1. The specifications and drawings for Invitation No. DACW64-02-B-0031, Channel Rectification, Downstream of Cullen to State Highway 288, Sims Bayou, Houston, Texas, advertised 17 July 2002 and for which bids are to be opened on 20 August 2002, are hereby modified as follows:

**QUESTIONS FROM MIDWEST CONSTRUCTION COMPANY, ROBERT VITEK AND ANSWERS BY THE GALVESTON DISTRICT DESIGN TEAM**

File 7586S  
**SIMS BAYOU, HOUSTON, TEXAS,  
 DOWNSTREAM OF CULLEN TO  
 STATE HIGHWAY-288,  
 CHANNEL RECTIFICATION**

**INVITATION NO. DACW64-02-B-0031**

(PLAN FROM DRAWING) S-5

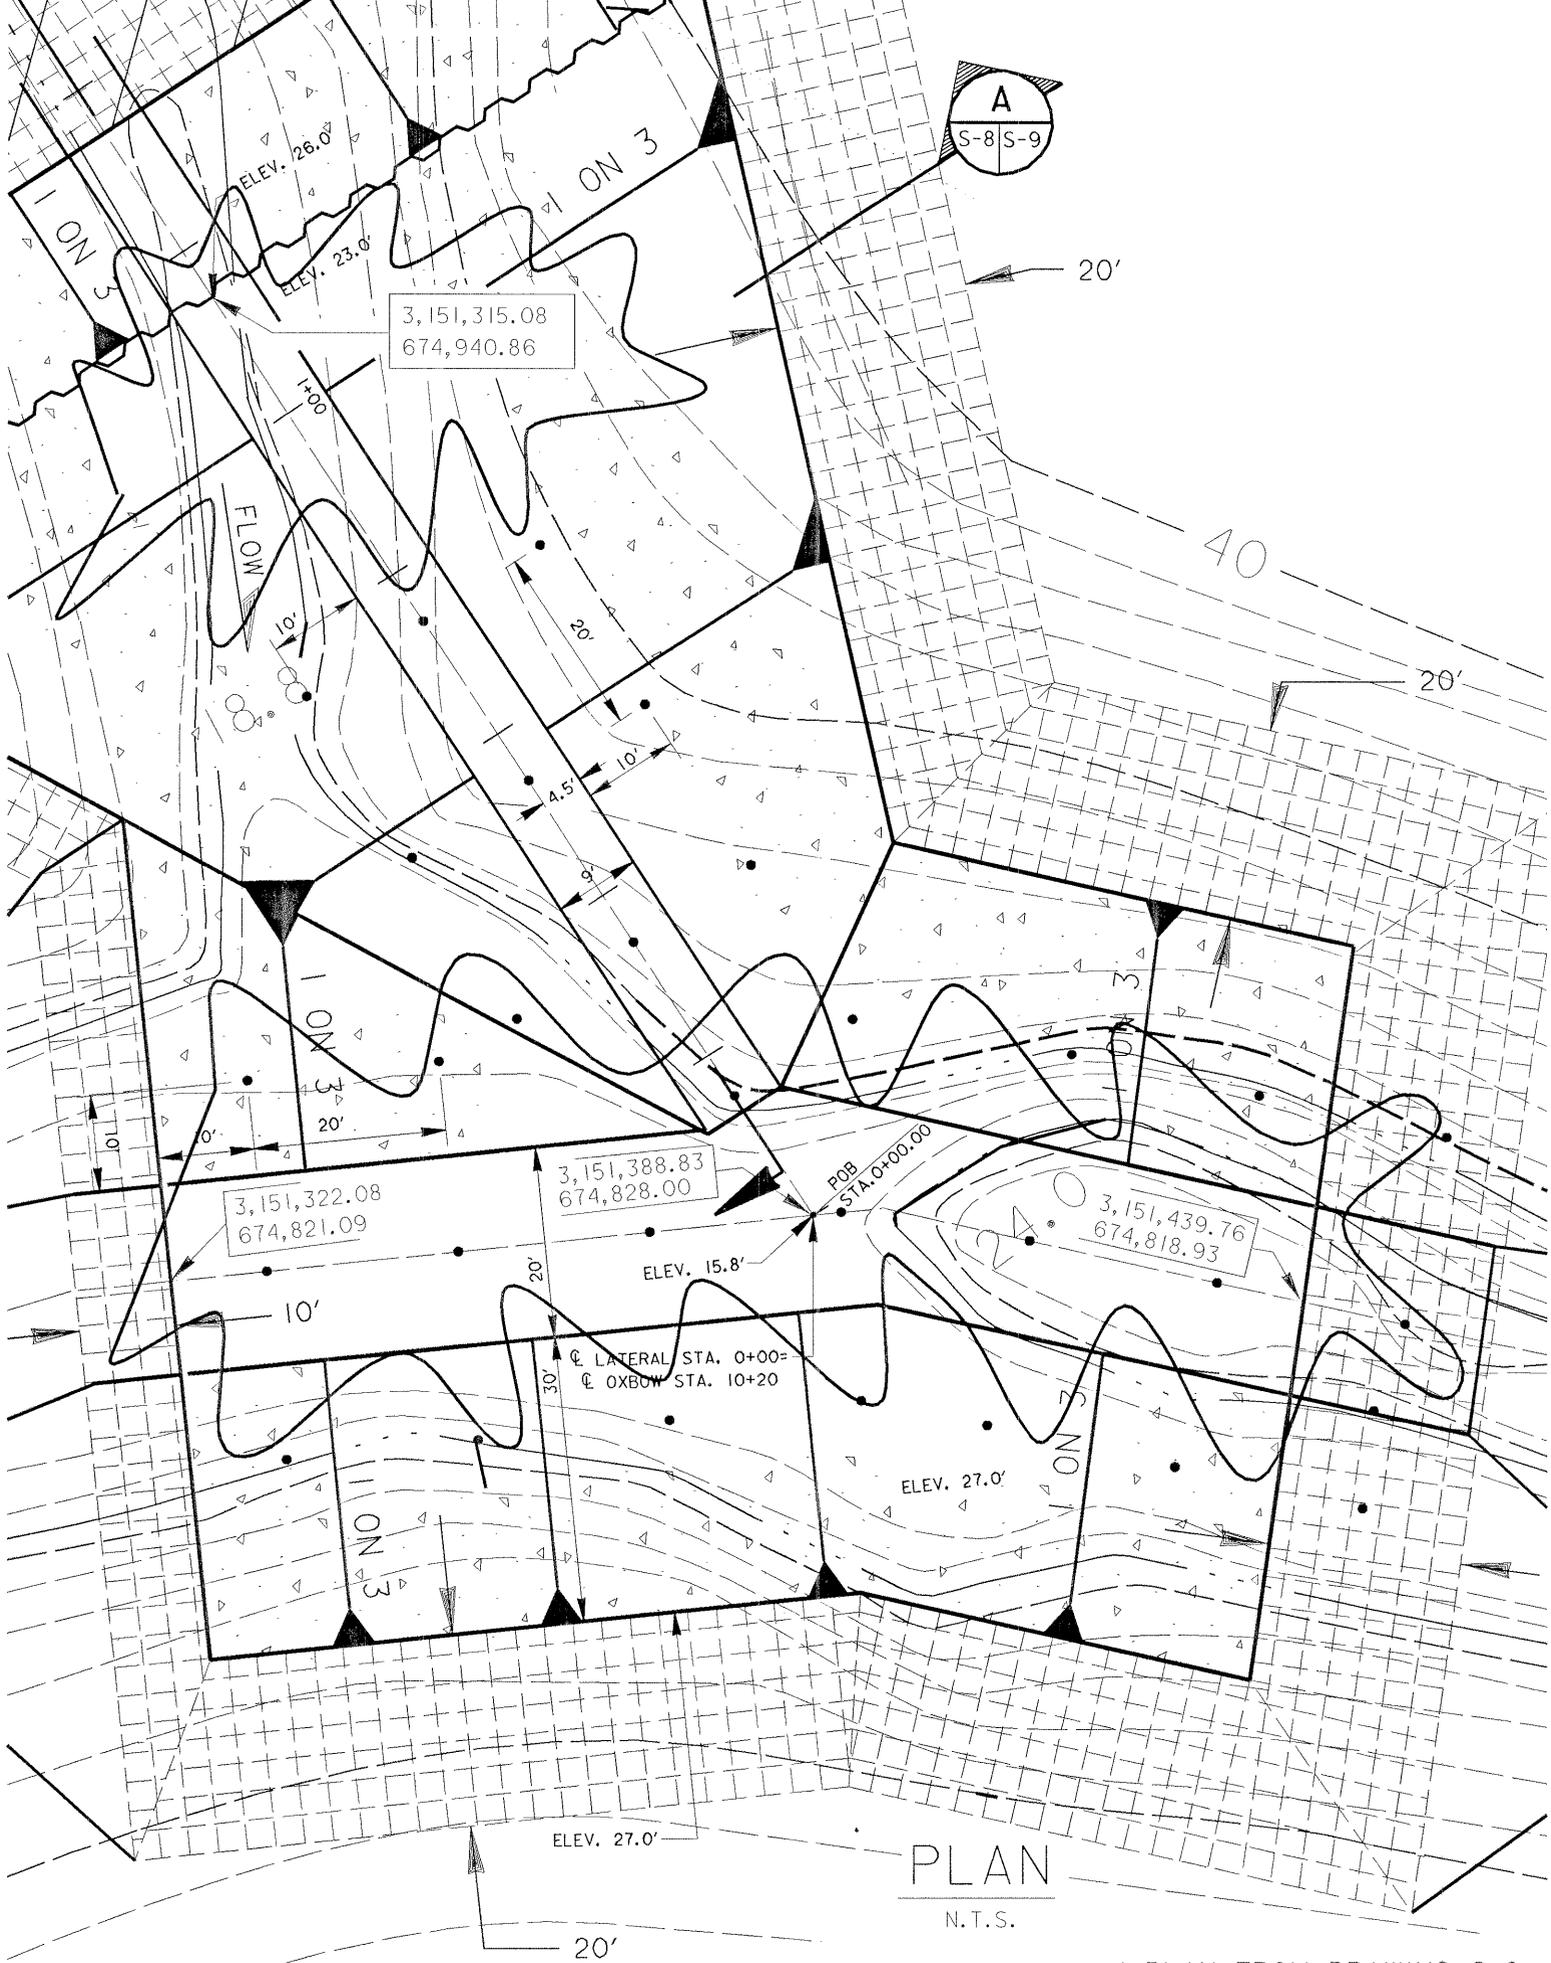
(32) Drawing No. S-5 - The enclosed ATTACHMENT NO. 1 showing a revision to the location of SECTION B/S5/S6 becomes a part of DRAWING NO. S-5 issued with this Invitation.

ATTACHMENT NO. 2

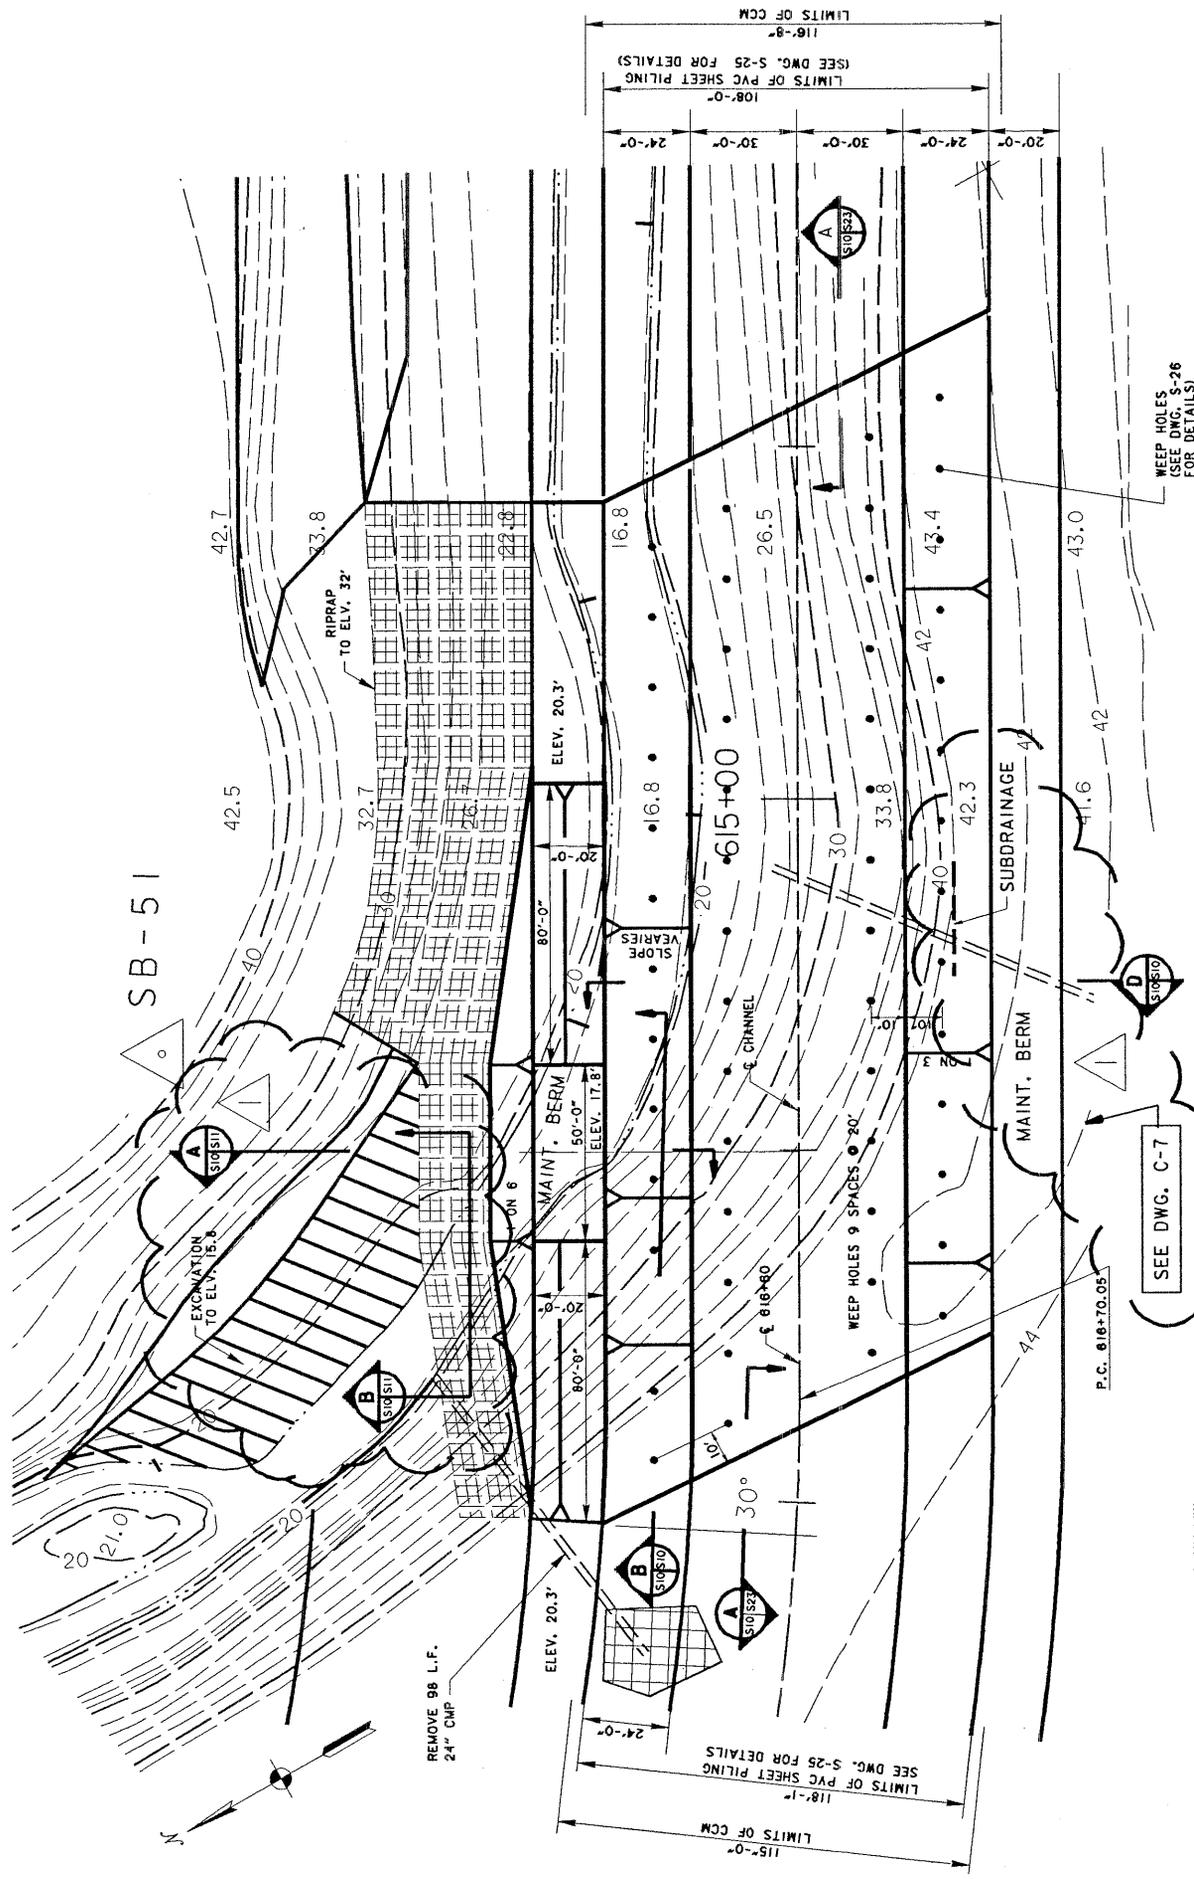
(34) Drawing No. S-8 - The enclosed ATTACHMENT NO. 2 showing layout coordinates shall become a part of DRAWING NO. S-8 issued with this Invitation.

"TO ACCOMPANY AMENDMENT NO. 0001  
TO INVITATION NO. DACW64-02-B-0031."  
ATTACHMENT NO. 3

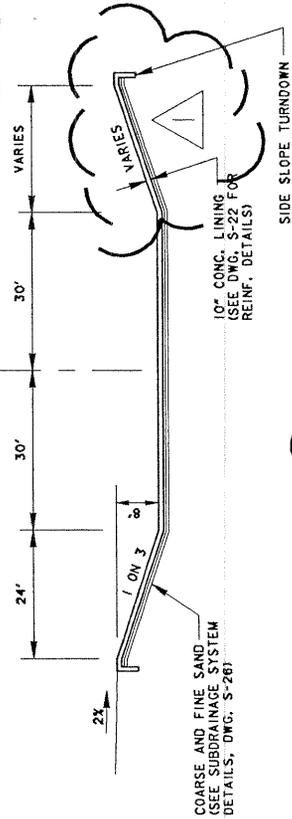
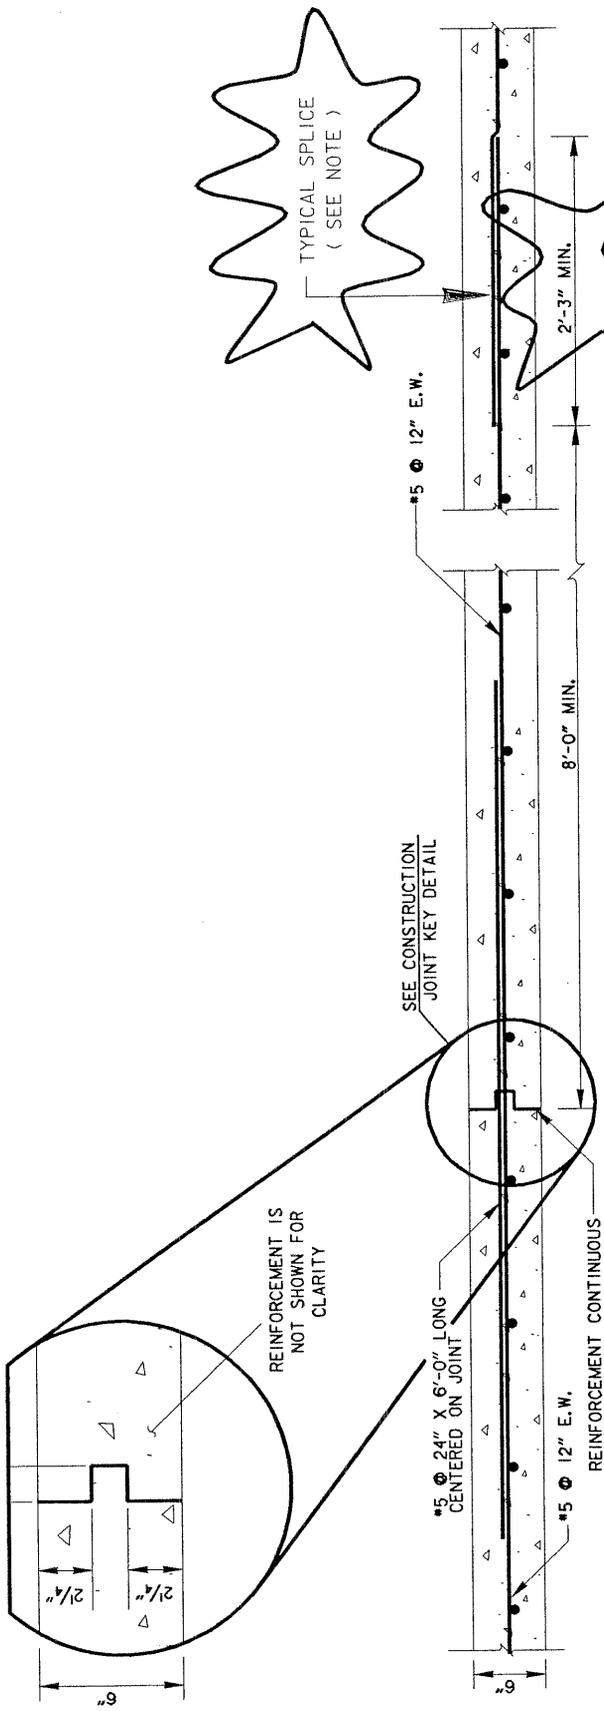
(35) Drawing No. S-10 - The enclosed ATTACHMENT NO. 3 shall become a part of DRAWING NO. S-10 issued with this Invitation.

ATTACHMENT NO. 8

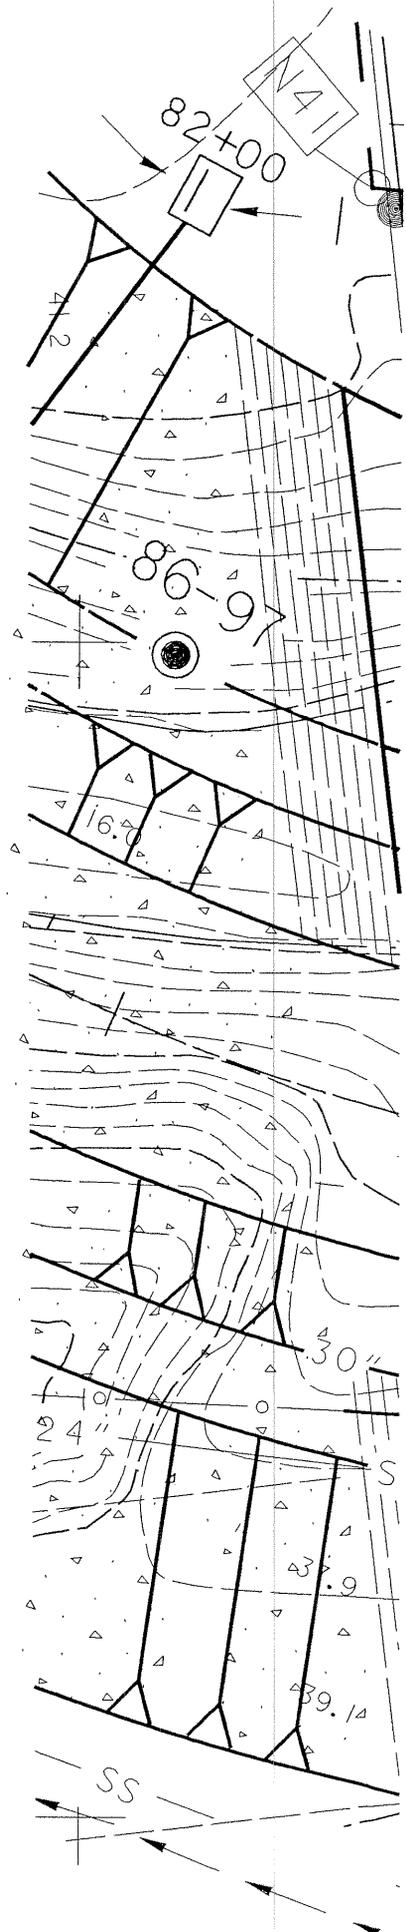
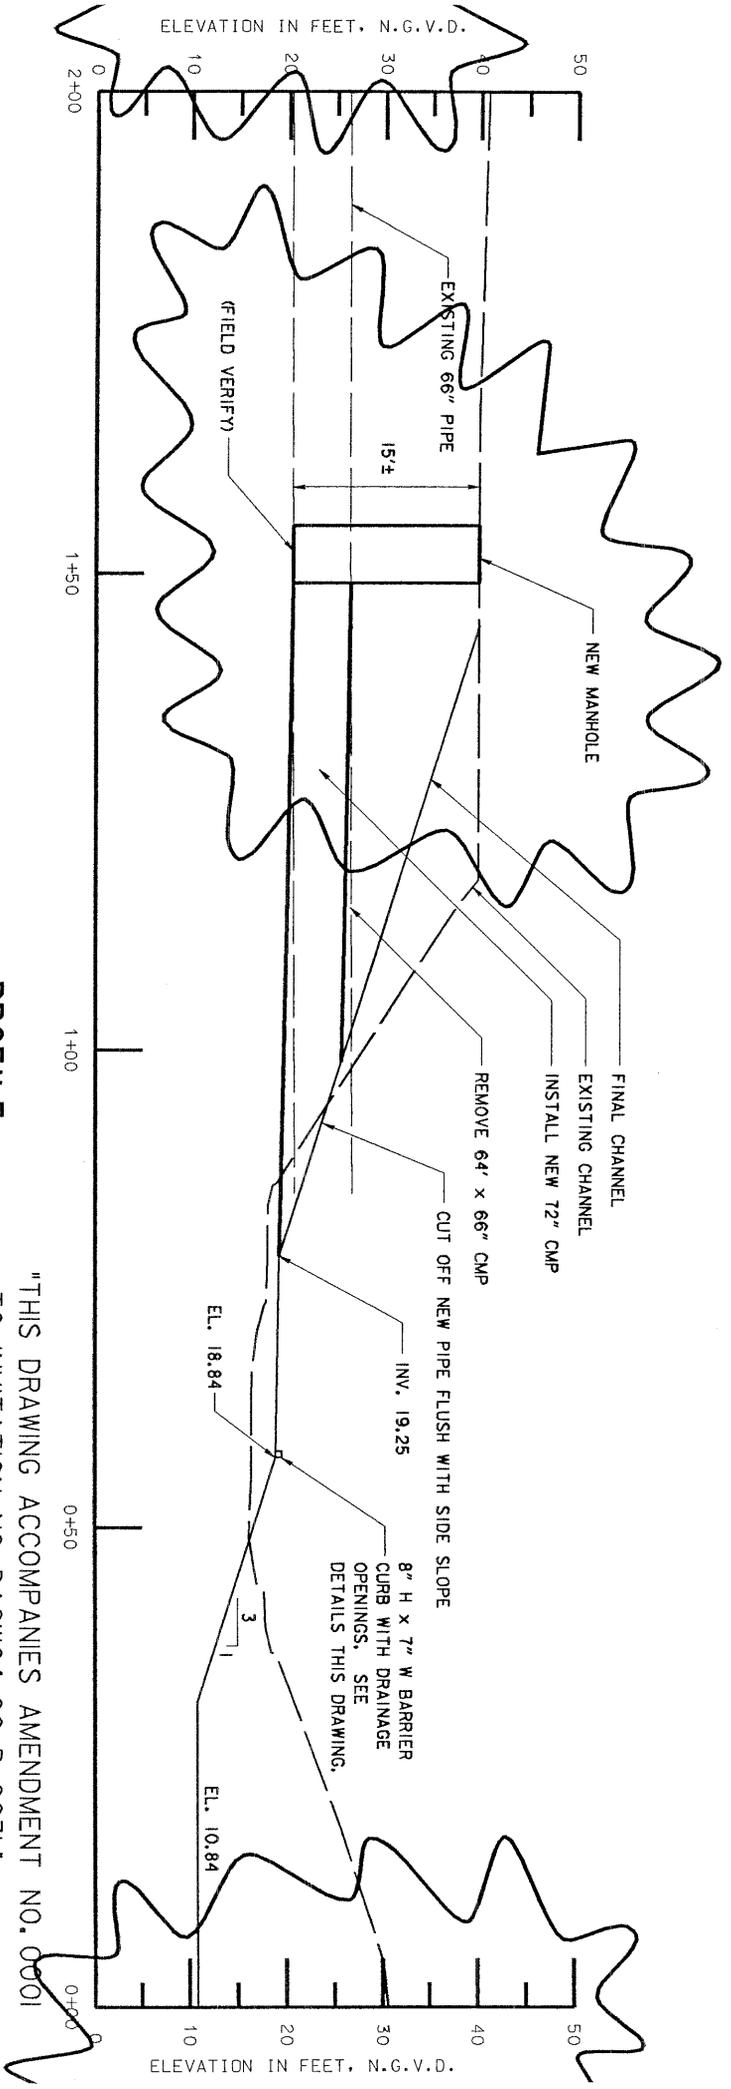
(49) Drawing No. S-33 - In the TITLE BLOCK change, “NLET” to “INLET.” Also, the enclosed ATTACHMENT NO. 8 shall replace a portion of the PROFILE shown on DRAWING NO. S-33.
